Point Sheridan Art Project Summary of Design Changes

In response to the Design Review Board (DRB) and BCDC staff comments made on the artwork entitled "Changing Tides," as proposed for Point Sheridan, the following revisions and clarifications are being submitted.

Figure 1: Art Site Plan

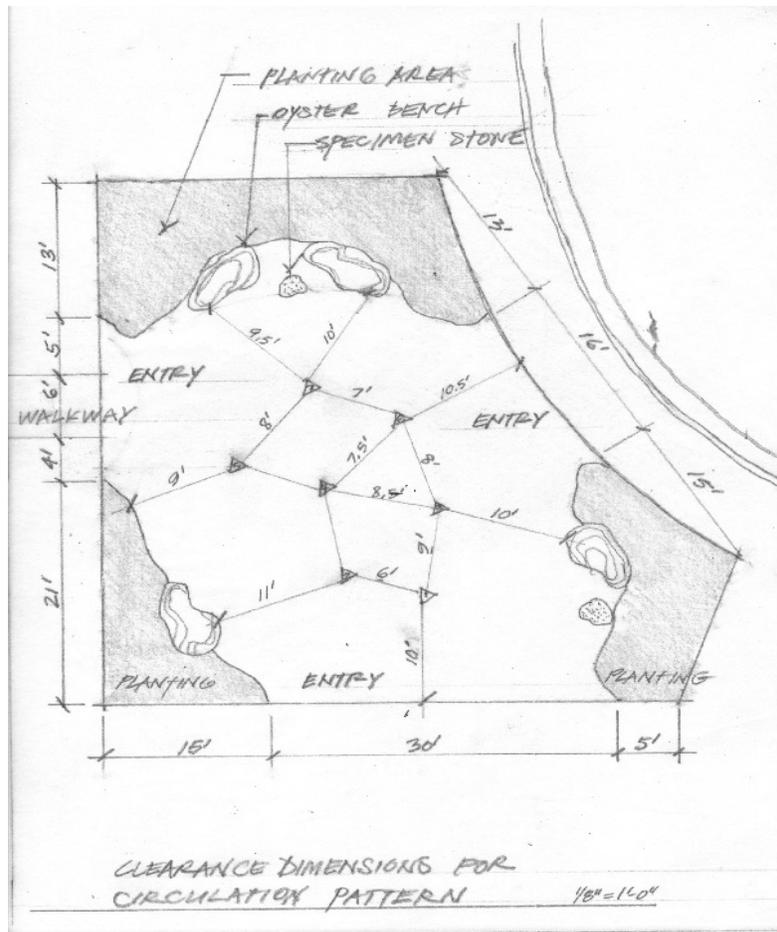
1. Art Site Footprint: WETA has proposed moving the art site approximately 8' to the west of the original art site, as presented to the DRB and staff on July 13, 2015. The art site location and its relationship to the design work being proposed by WETA is illustrated in Figure 1 and will be further detailed in renderings to be presented by WETA.

2. Concrete to replace decomposed granite: The ground plane of the art site is now colored, lightly textured concrete that provides better continuity between it, the existing concrete, and the new concrete pathways to be provided by WETA around the art site. The art site concrete area now measures approximately 1, 578 square feet, as illustrated in Figure 1.

3. West Entry Access: WETA has provided a new concrete pathway to the west of the art site which allows ADA access to the art site from the parking lot as illustrated in Figure 1.

7. Interpretive Signage: Interpretive signage will be placed adjacent to the Bayshore trail and will describe the artwork and its intent to illustrate the changing landscape of the site over the century, the importance of the marshlands to the Bay's ecosystem and an explanation of the solar/light and tidal components of the sculpture. The interpretive signage is shown in Figure 1 at the southeast corner of the art site.

8. Lighting: The location of the new light bollards is shown in Figure 1. Detailed drawings on the lighting are to be provided by WETA.

Figure 2: Clearances for circulation pattern between sculptures

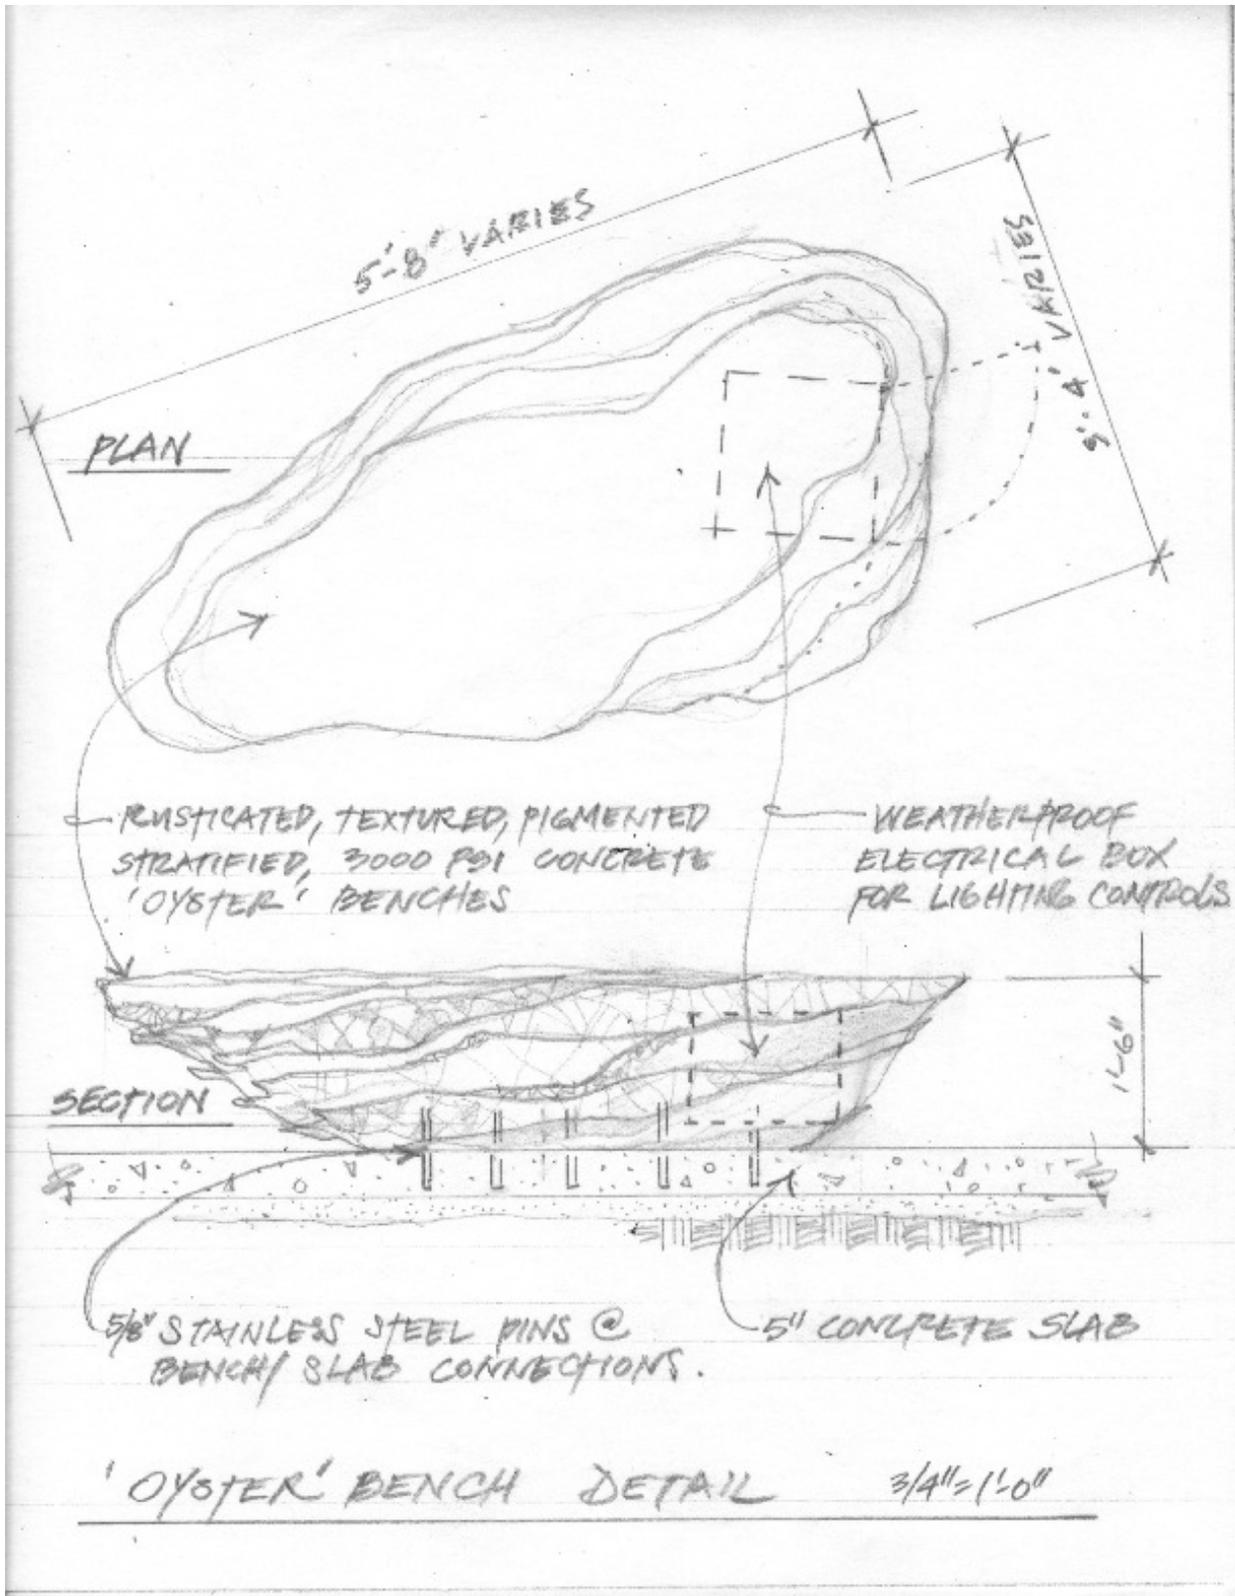
4. Pedestrian Clearances: The clearances between each sculpture have been increased to improve ADA compliance, as shown in Figure 2.
5. Planting Plan: The planting plan has been revised to include only *Juncus patens*, as recommended by staff. The *Juncus patens* plant is illustrated in Figure 3.

Figure 4: Oyster Bench Detail

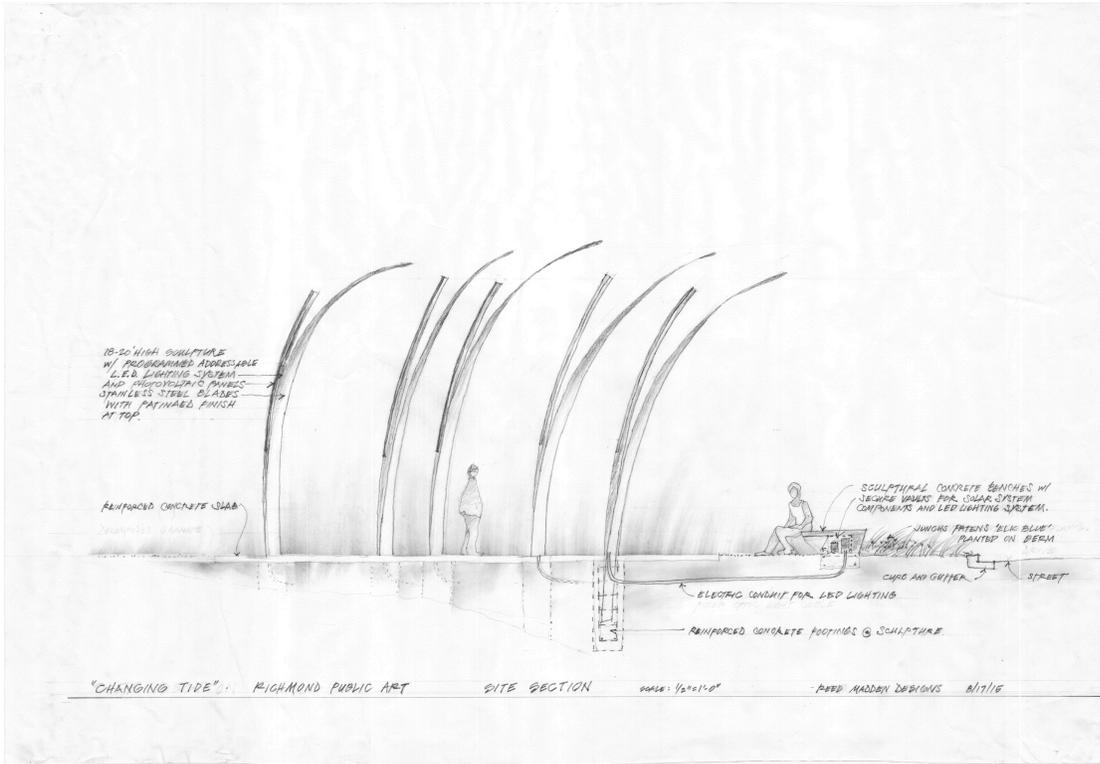
6. Sculptural Benches: The oyster shaped benches have been detailed out, as illustrated in Figures 4-6. Typical concrete patterns to be used on the benches are illustrated in Figure 7.
